Town of Hilton Head Island
Design Review Board Meeting
Tuesday, June 28, 2022 – 1:15 p.m.
AGENDA

DESIGN TEAM/DRB COMMENT SHEET

PROJECT NAME: Lowes Foods #284

DRB#: DRB-001572-2022

ENLARGED PARKING MODIFICATION - NEW WORK PLAN
SCALE: 1/16" = 1'-0"

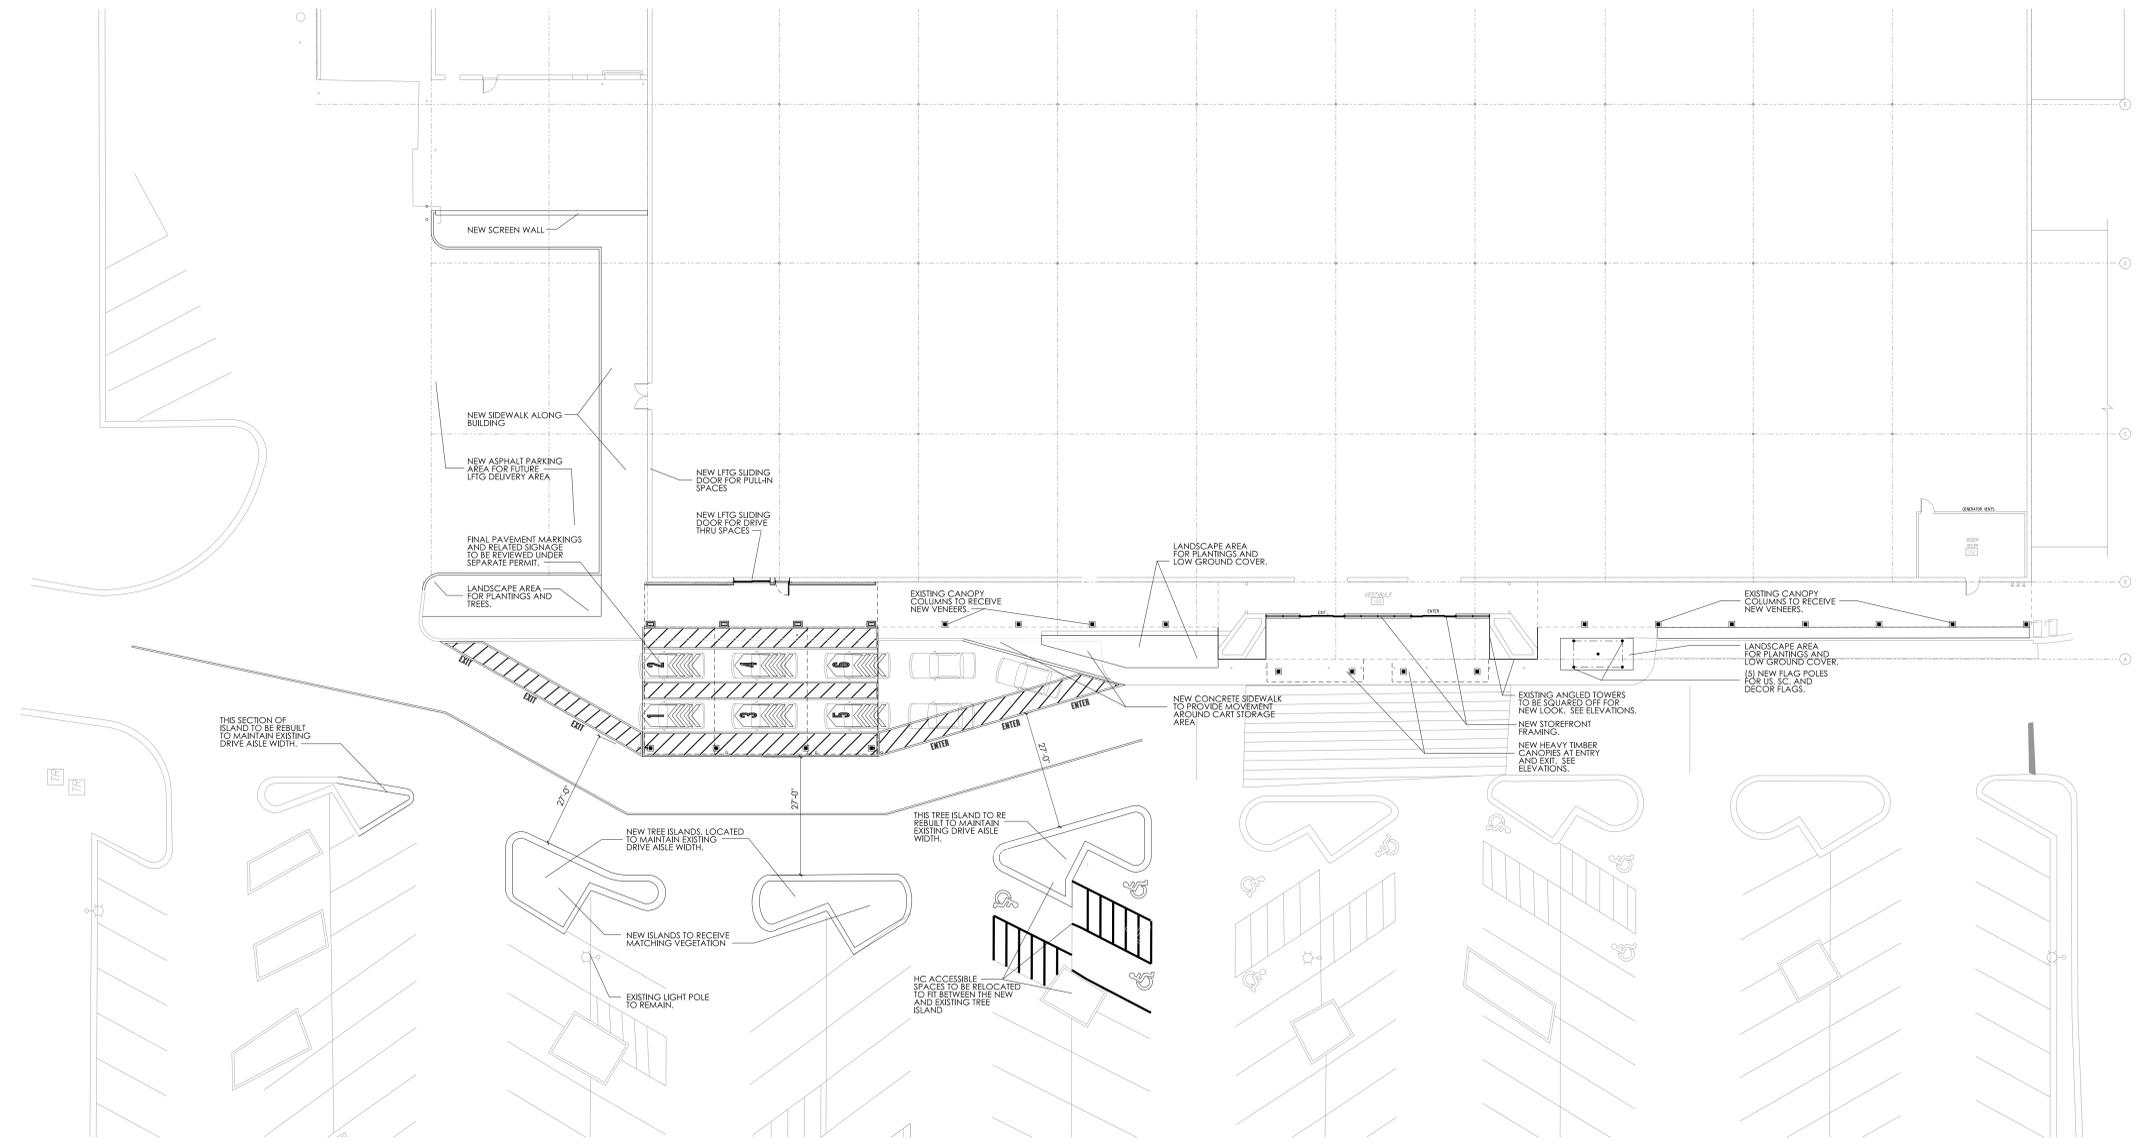
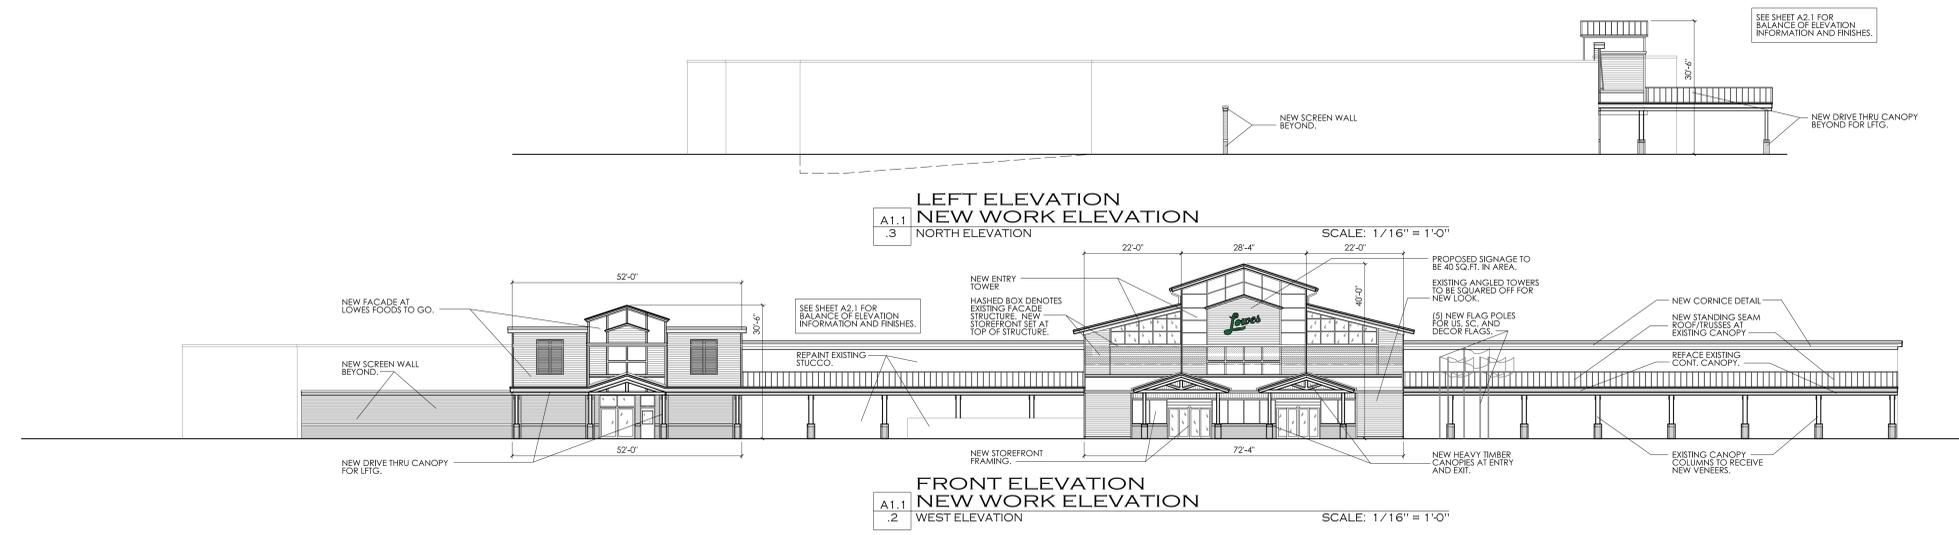
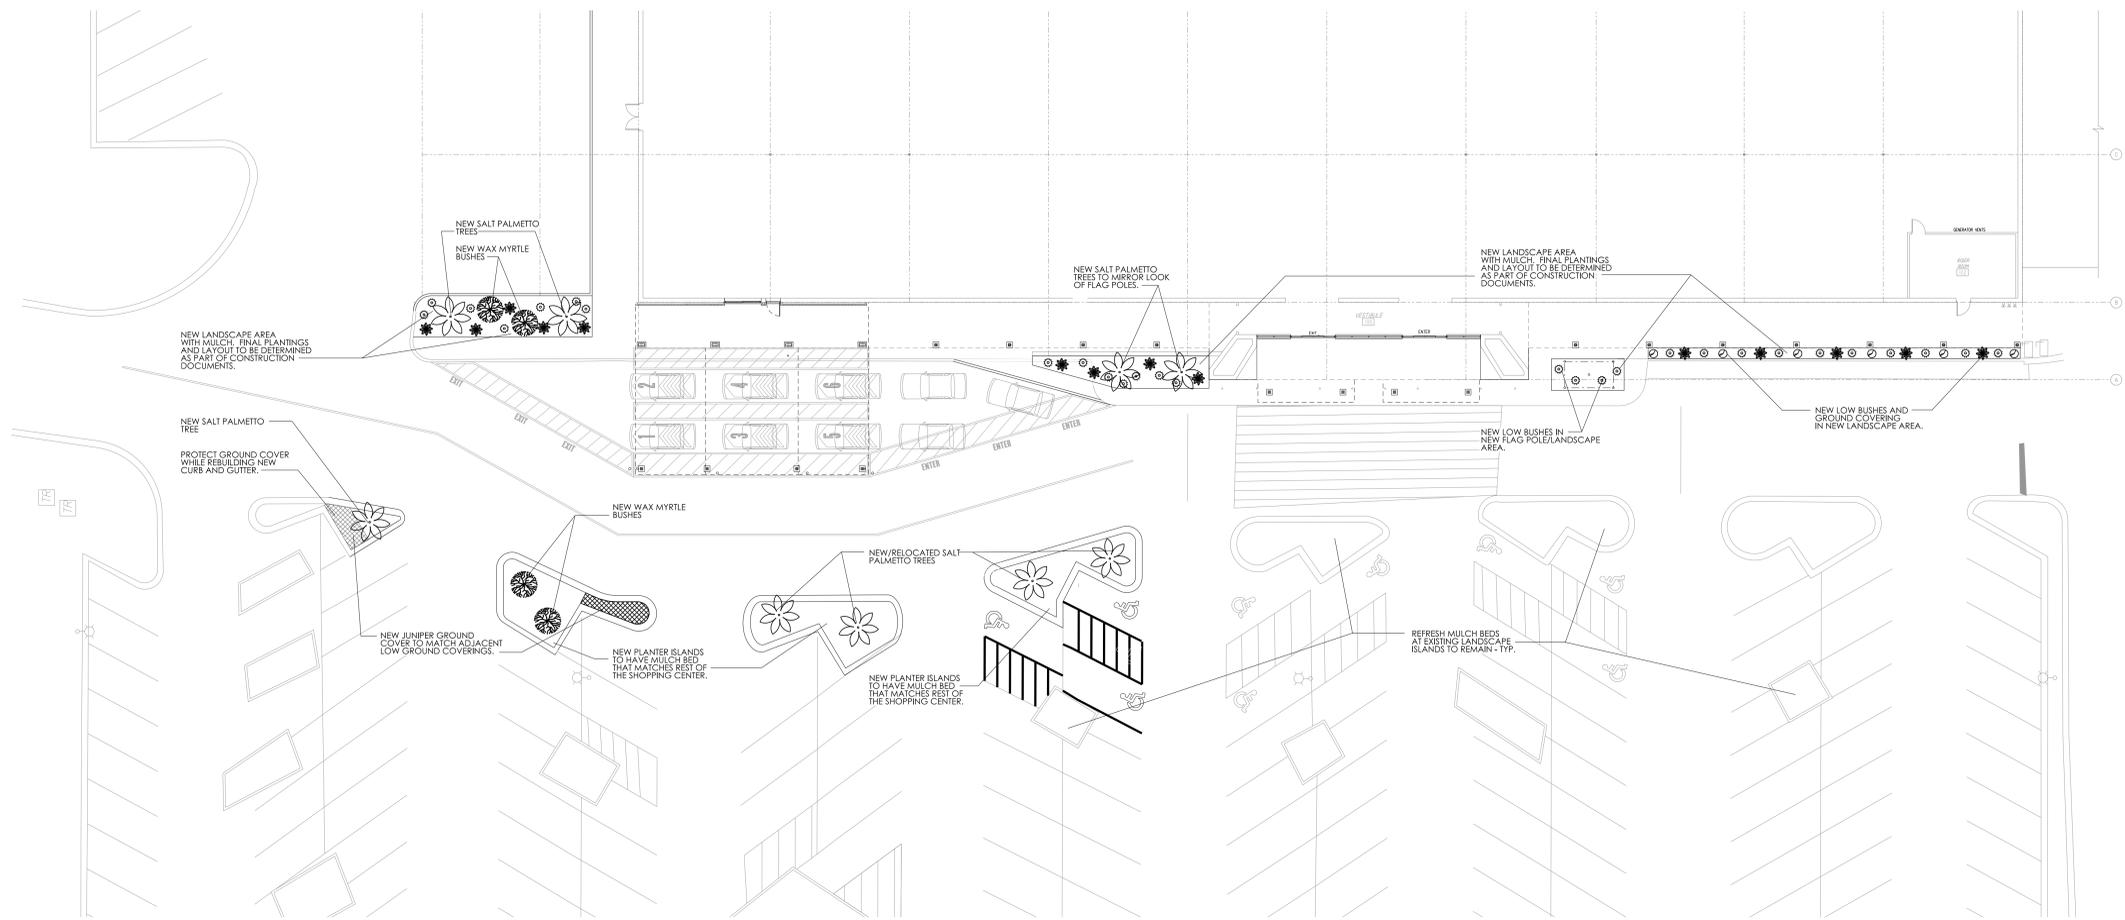
DESIGN GUIDE/LMO CRITERIA	Complies Yes	No	Not Applicable	Comments or Conditions
Design is appropriate for its use	<input type="checkbox"/>	<input checked="" type="checkbox"/>	<input type="checkbox"/>	Provide a curb where covered loading area extends into the parking lot to protect the columns and define the pickup area.

A1.2
 LOWES FOODS
 ST. #284

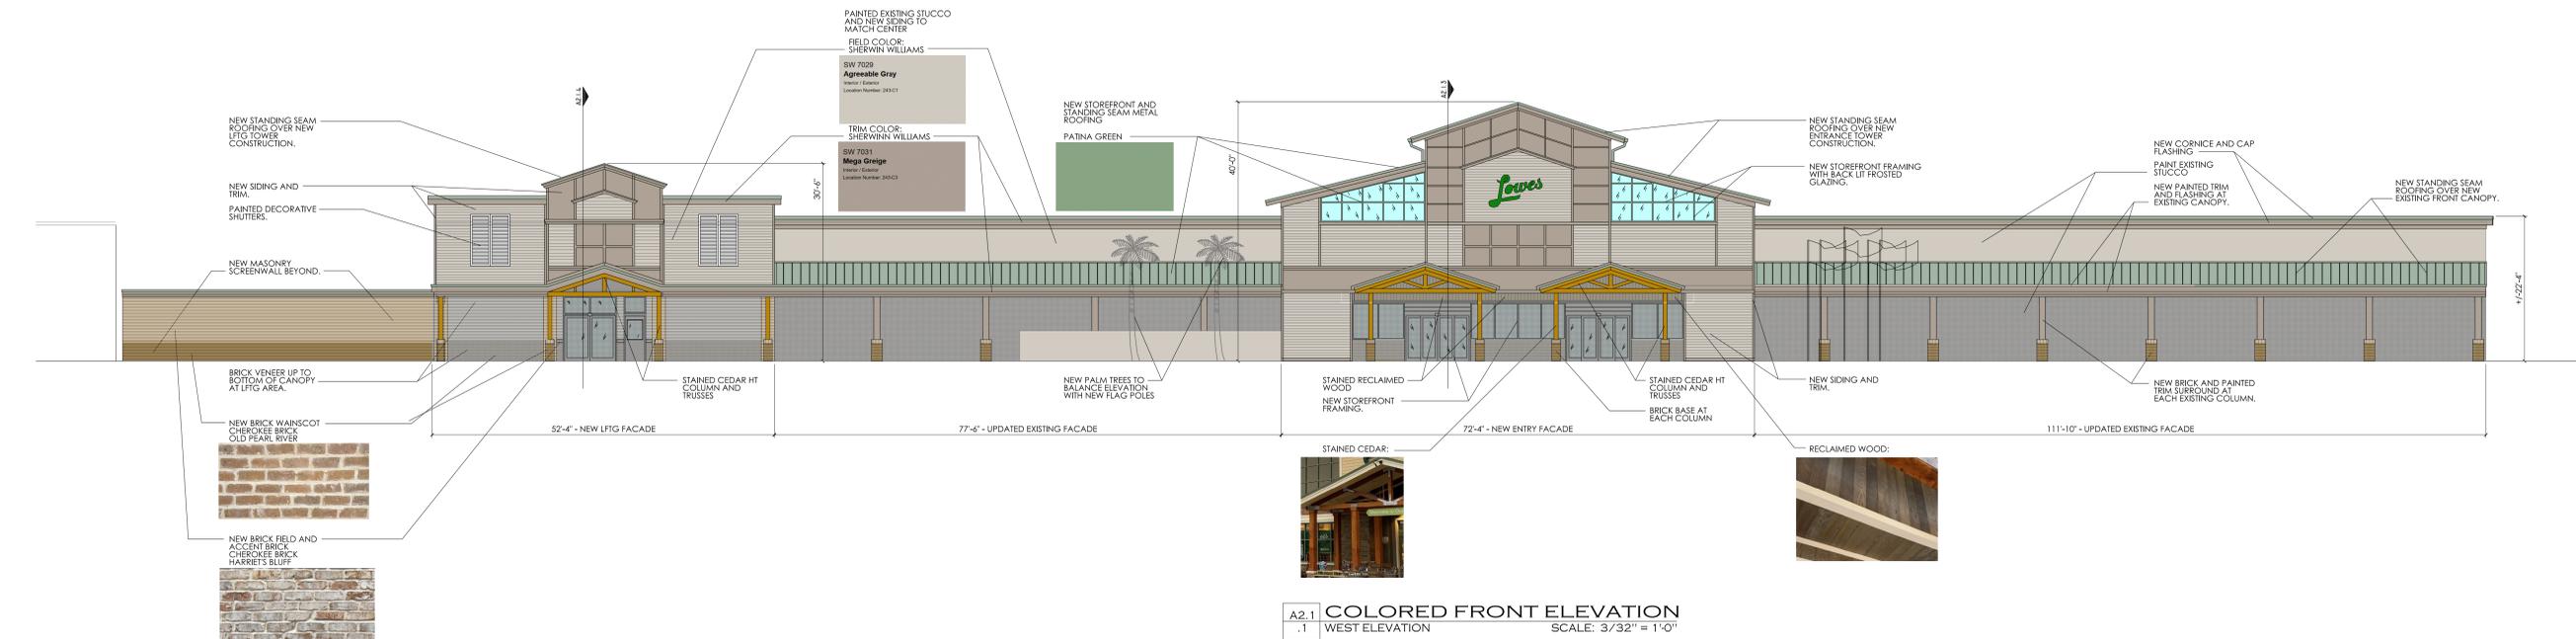
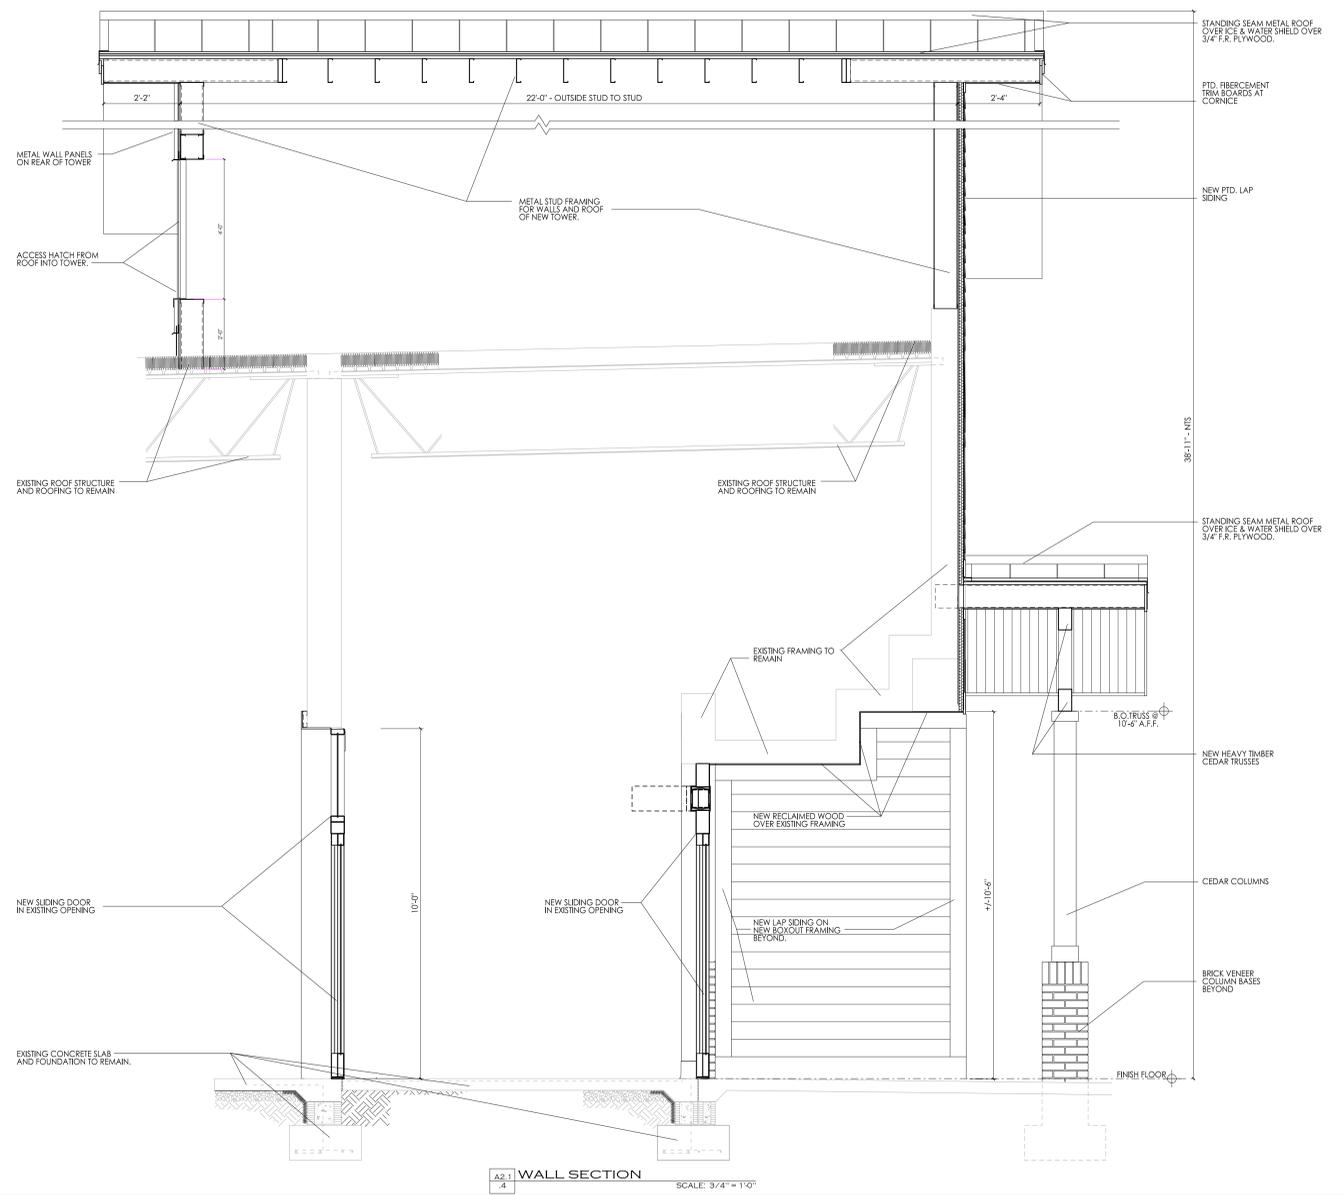
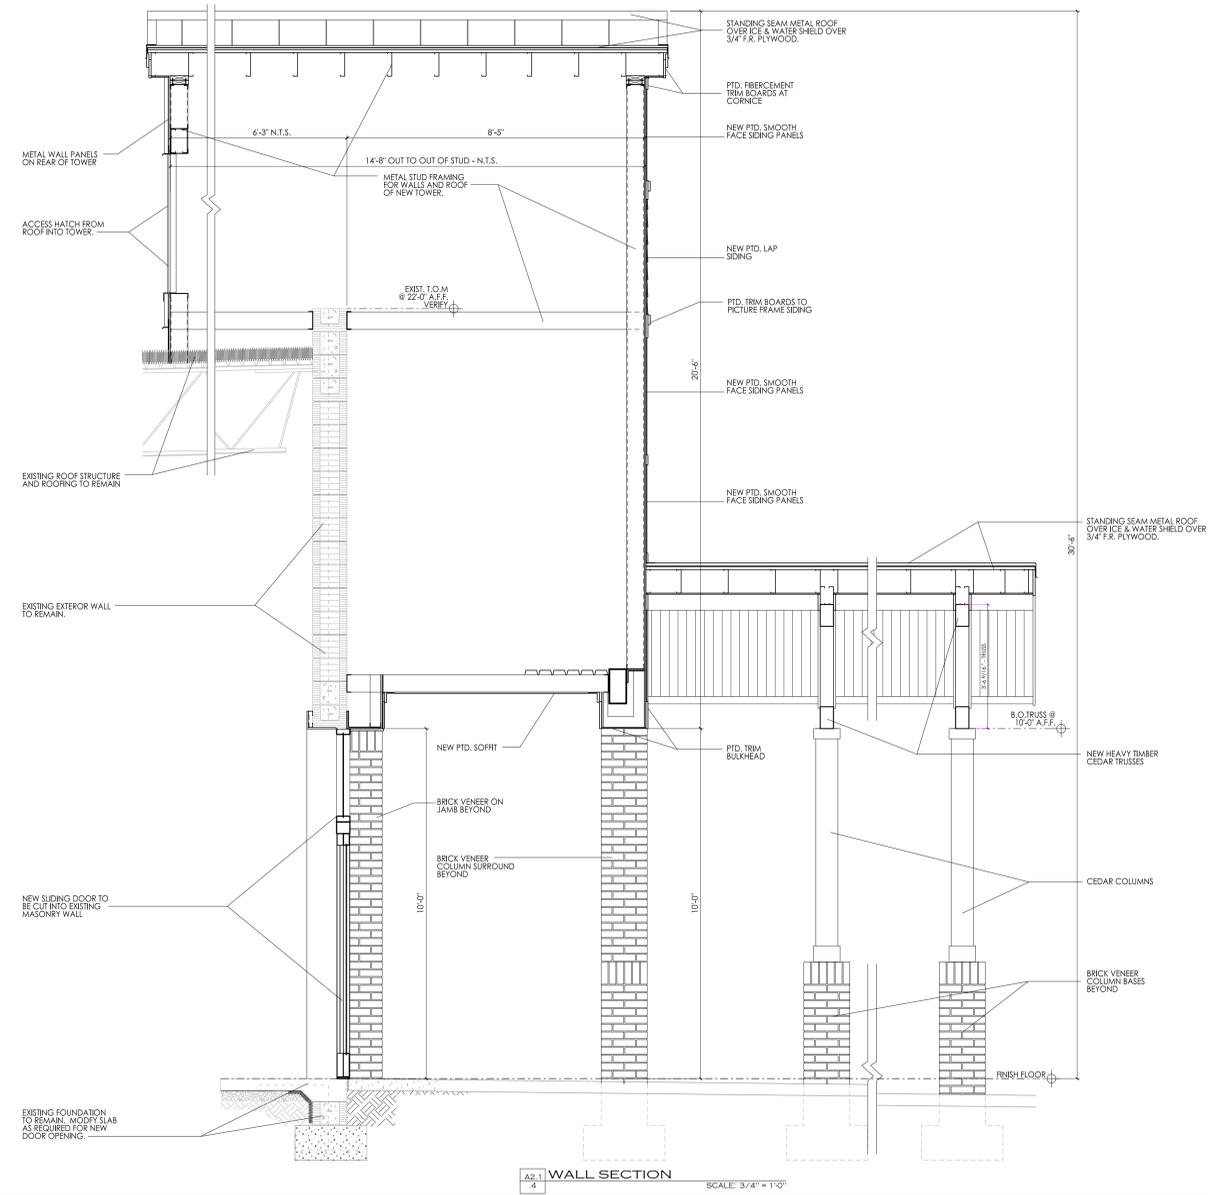
1. Create a landscape area on the right of the front entrance to mirror the landscape area on the left. Add large trees to frame the entrance.
2. Submit a revised landscape plan for Staff review and approval that includes quantities, species, and sizes.

DESIGN GUIDE/LMO CRITERIA	Complies Yes	No	Not Applicable	Comments or Conditions
Provides overall order and continuity of the Landscape plan	<input type="checkbox"/>	<input checked="" type="checkbox"/>	<input type="checkbox"/>	<ol style="list-style-type: none"> 1. The landscape plan appears a little light on quantity given the scale of the building. 2. Shift the flag poles further to the right of the main entrance to accommodate a landscape area (mirror of left side) for canopy trees to breakup the mass of the building and frame the front entrance (palms are not adequate at

<p>this scale). Staff suggests Live Oak, Holly or Drake Elm.</p>
--	--	--	--	--
